STRATHFIELD COUNCIL **APPROVAL** DA2015/100/03 Date: 20/12/2017

S96 NOTES:

PROPOSED RESIDENTIAL DEVELOPMENT 84 CENTENARY DRIVE, STRATHFIELD NSW 2135 CHECKED BY: NM DATE: 038-S96-04 JULY 2017

Ground Floor Building A

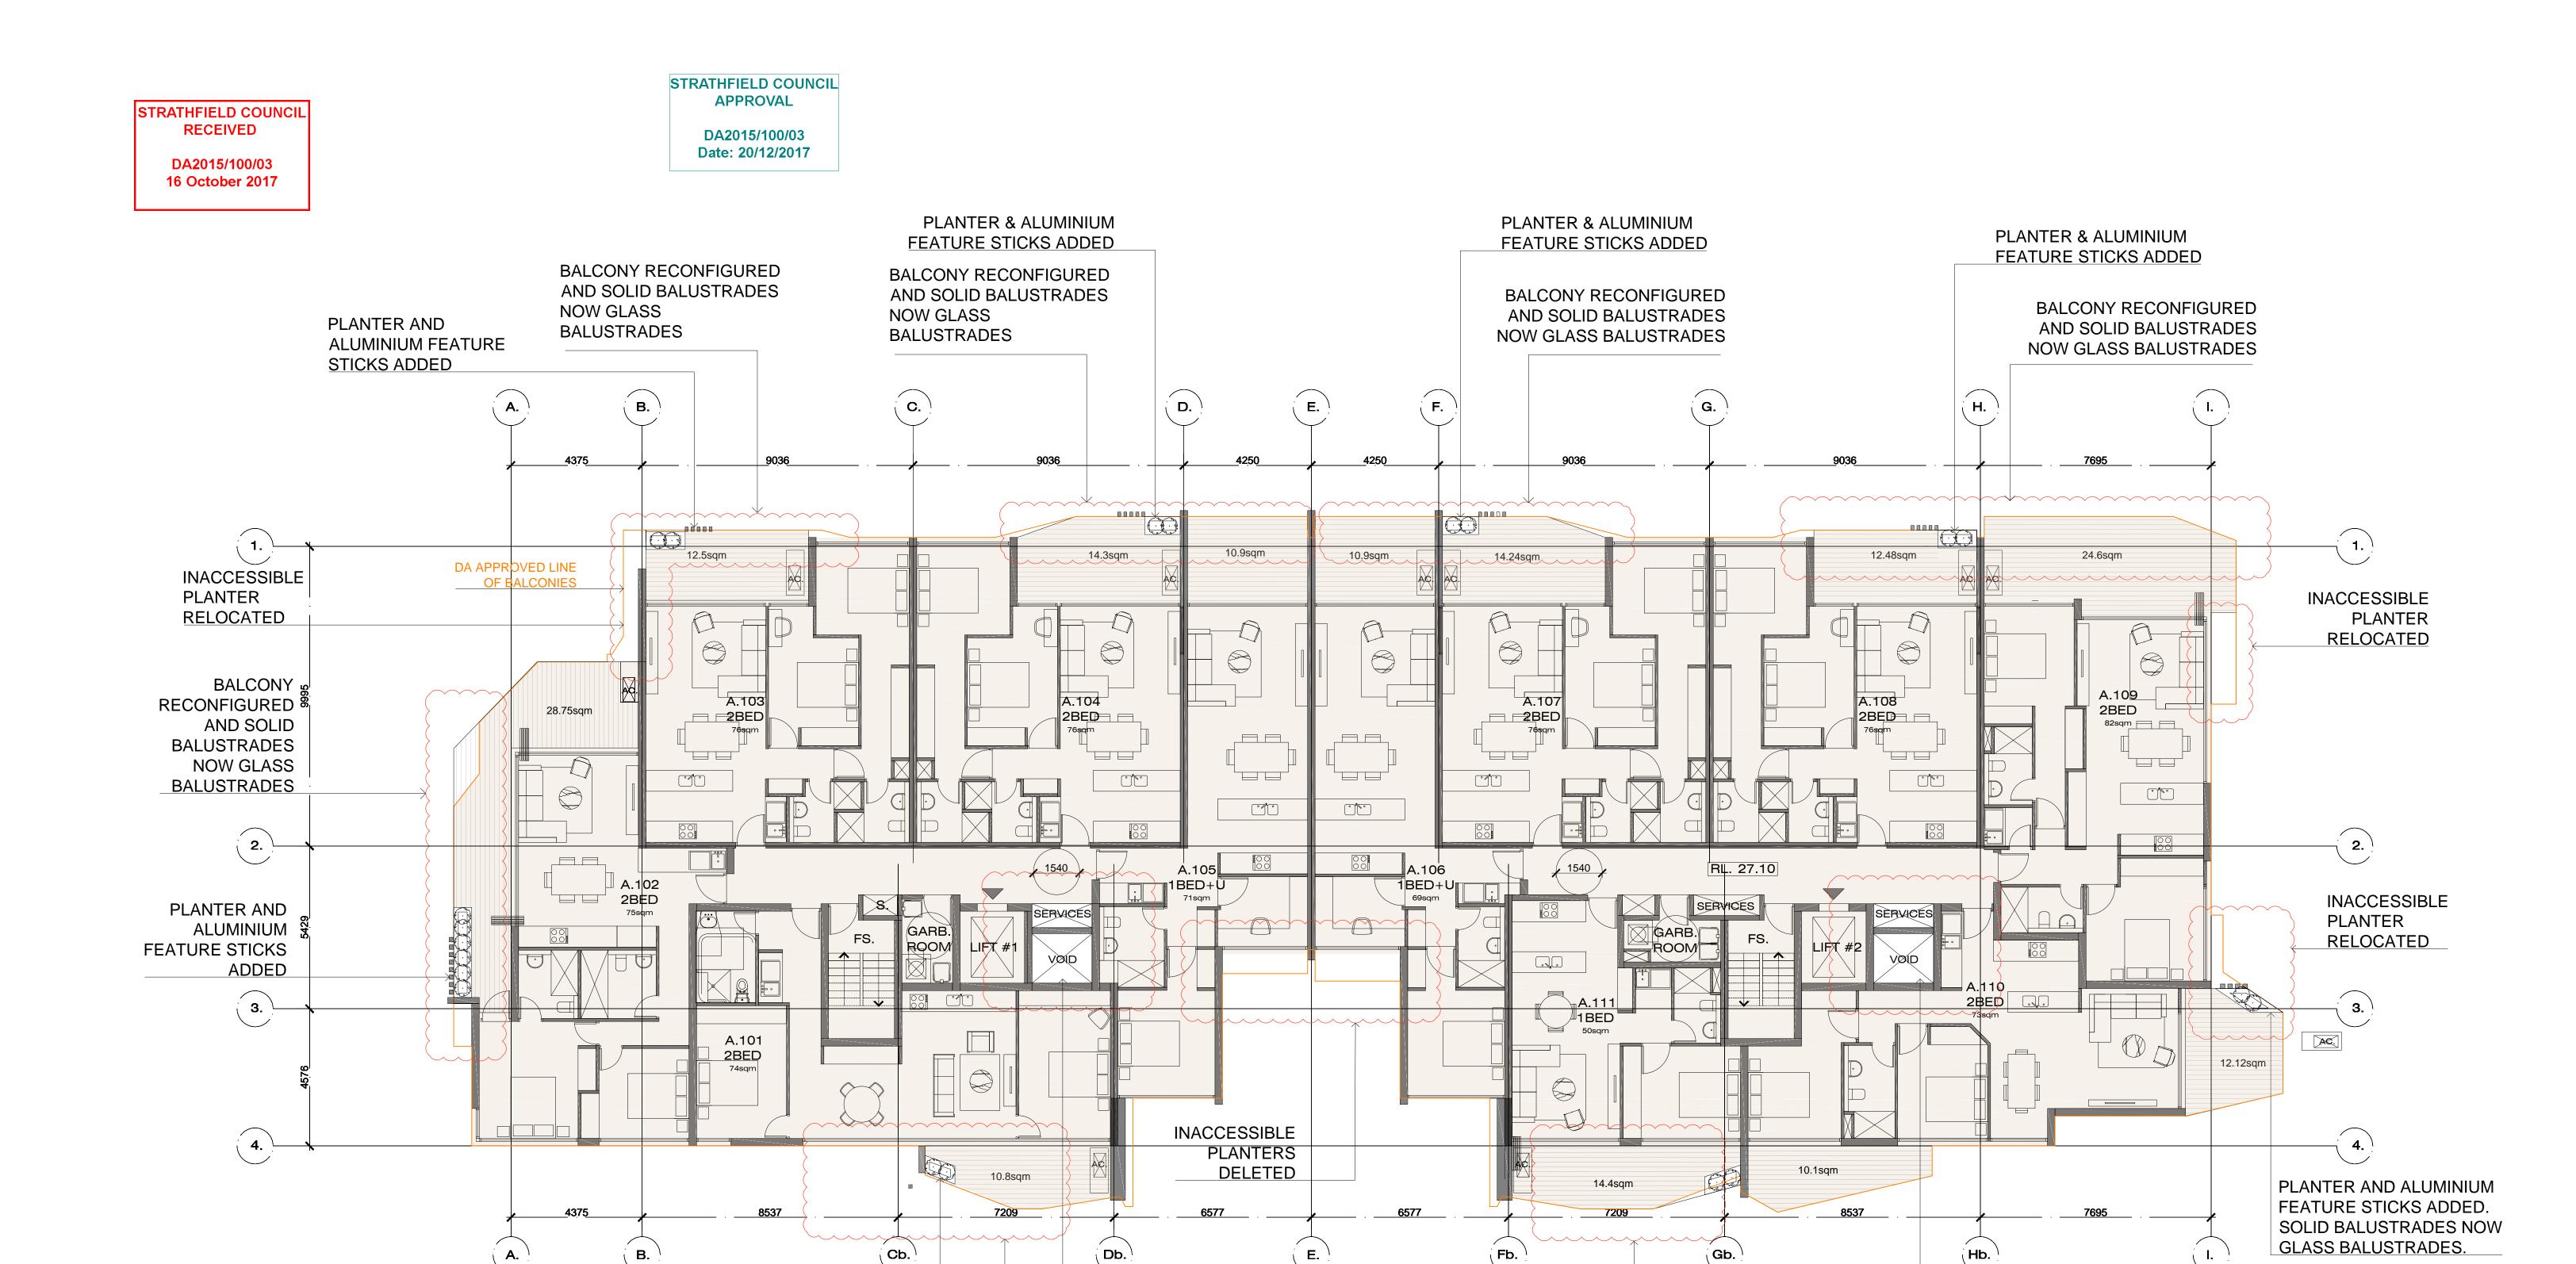
- 1. ALL SOLID BALUSTRADES NOW TO BE GLASS BALUSTRADES ASIDE FROM RELOCATED SOLID PLANTER PORTIONS
- 2. SOME BALCONIES RECONFIGURED
- 3. SOLID PLANTERS AND ALUMINIUM FEATURE STICKS ADDED
- 4. DELETION OF 2X ADDITIONAL LIFTS AT EACH BUILDING CORE
- 5. ALL GLAZING TO LIVING AND BEDROOMS RECONFIGURED TO FULL **HEIGHT**
- 6. ROOF PROFILE RECONFIGURED
- NO CHANGES TO APPROVED BUILDING FOOTPRINT OR GFA

DA APPROVED BALCONY CONFIGURATION S96 PROPOSED BALCONY CONFIGURATION

Level 1
Building A

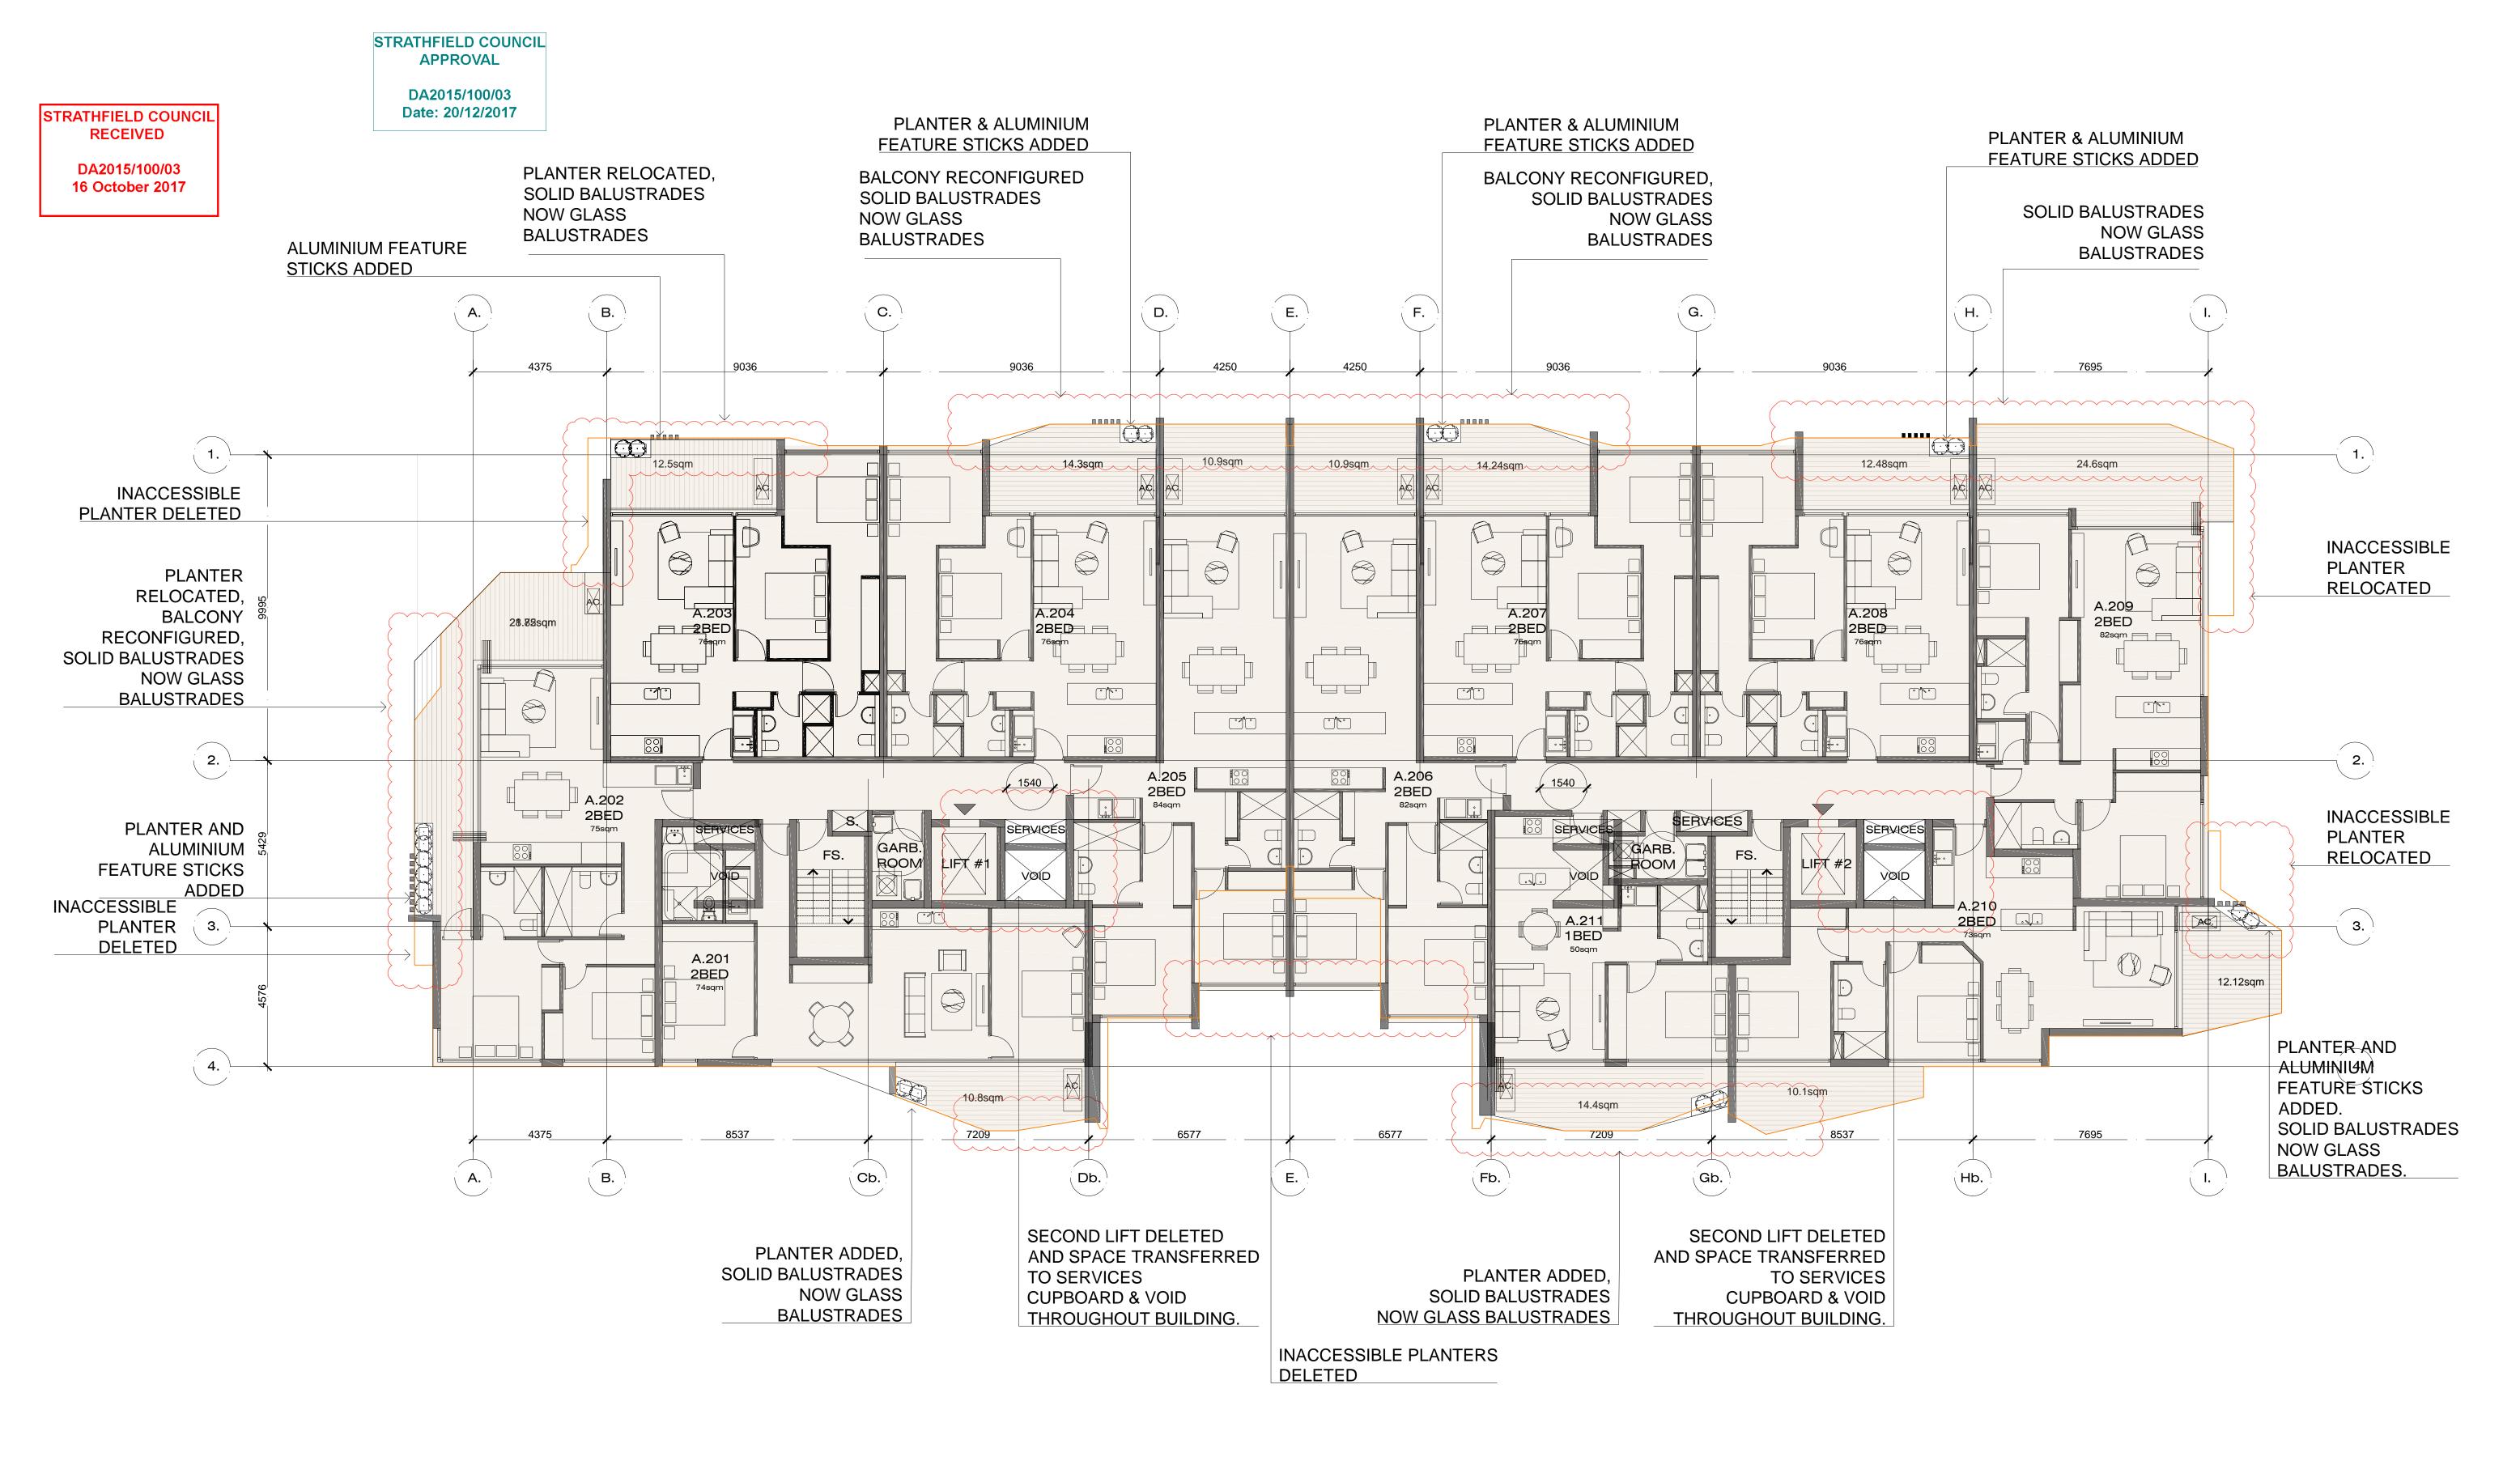
SECOND LIFT DELETED

TO SERVICES

CUPBOARD & VOID

AND SPACE TRANSFERRED

THROUGHOUT BUILDING.

BALCONY RECONFIGURED

AND SOLID BALUSTRADES

NOW GLASS BALUSTRADES

- 1. ALL SOLID BALUSTRADES NOW TO BE GLASS BALUSTRADES ASIDE FROM RELOCATED SOLID PLANTER PORTIONS
- 2. SOME BALCONIES RECONFIGURED
- 3. SOLID PLANTERS AND ALUMINIUM FEATURE STICKS ADDED
- 4. DELETION OF 2X ADDITIONAL LIFTS AT EACH BUILDING CORE
- 5. ALL GLAZING TO LIVING AND BEDROOMS RECONFIGURED TO FULL HEIGHT
- 6. ROOF PROFILE RECONFIGURED
- 7. NO CHANGES TO APPROVED BUILDING FOOTPRINT OR GFA

DA APPROVED BALCONY

S96 PROPOSED BALCONY

Level 2-4 Building A

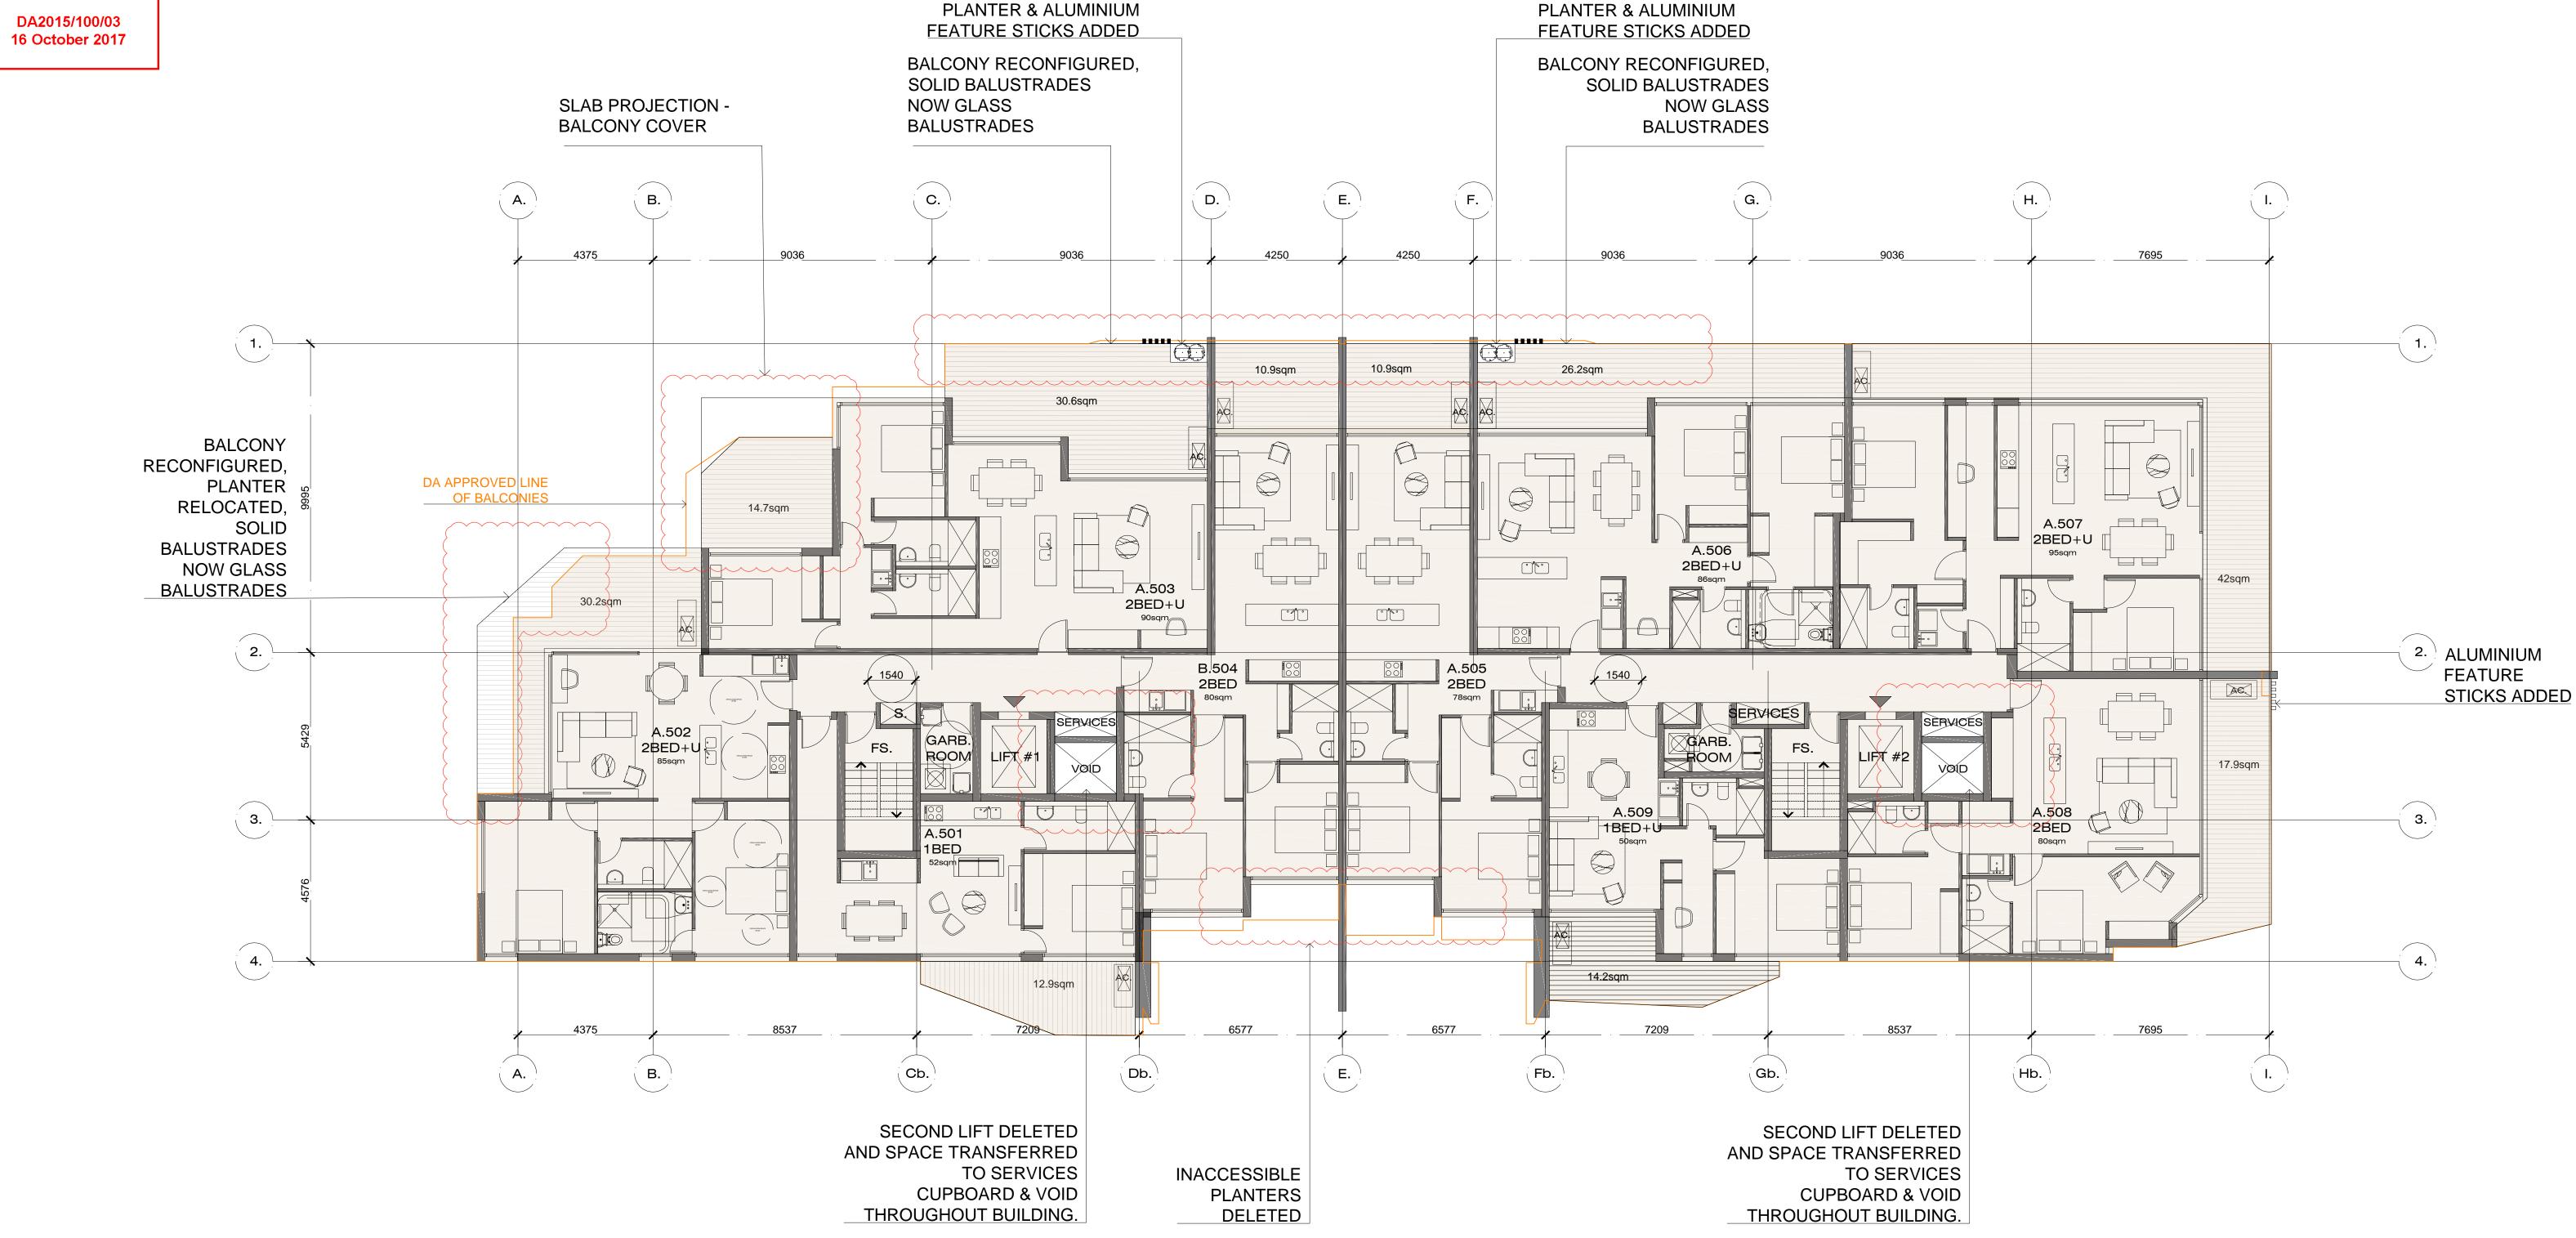
BALCONY RECONFIGURED

AND SOLID BALUSTRADES

NOW GLASS

BALUSTRADES

PLANTER ADDED

SECOND LIFT DELETED

TO SERVICES

CUPBOARD & VOID

AND SPACE TRANSFERRED

THROUGHOUT BUILDING.

- 1. ALL SOLID BALUSTRADES NOW TO BE GLASS BALUSTRADES ASIDE FROM RELOCATED SOLID PLANTER PORTIONS
- 2. SOME BALCONIES RECONFIGURED
- SOLID PLANTERS AND ALUMINIUM FEATURE STICKS ADDED
- 4. DELETION OF 2X ADDITIONAL LIFTS AT EACH BUILDING CORE
- 5. ALL GLAZING TO LIVING AND BEDROOMS RECONFIGURED TO FULL HEIGHT
- 6. ROOF PROFILE RECONFIGURED
- 7. NO CHANGES TO APPROVED BUILDING FOOTPRINT OR GFA

DA APPROVED BALCONY CONFIGURATION S96 PROPOSED BALCONY CONFIGURATION
